Access Compliance Report

Public Rights-of-Way

(Curb Ramps)

| Intersection ID: 14086 | Main Street: BALDWIN_AV | Cross Street: E_3RD_ST | Location: W |

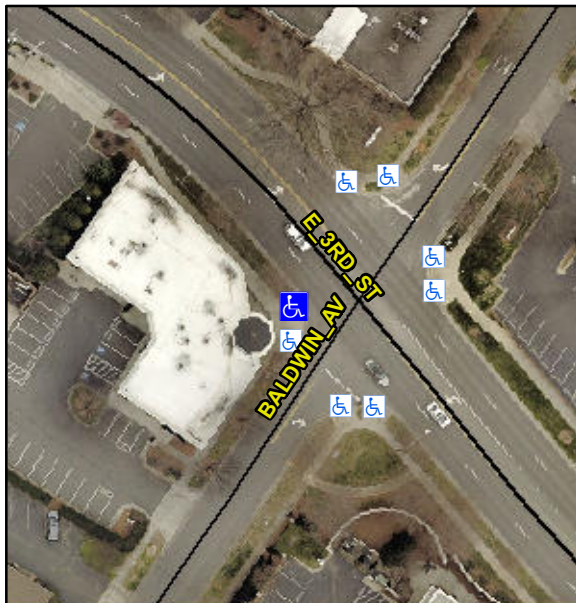
| ADA ID: DC5C6193AC12 | Ramp Type: Perp | Initial Pass/Fail: Fail | Overall Compliance: No |

R304.5.1, R304.2.2, R304.5.3

| Compliance | Description | Data | Compliance | Description | Data |
|------------|-----------------------|-------|------------|-----------------------------|------|
| N/A | Ramp Length (in) | 117.0 | No | Ramp Slope (%) | 8.6 |
| No | Ramp Width (in) | 35.0 | No | Ramp XSlope (%) | 3.8 |

Remove & Replace Entire Ramp.
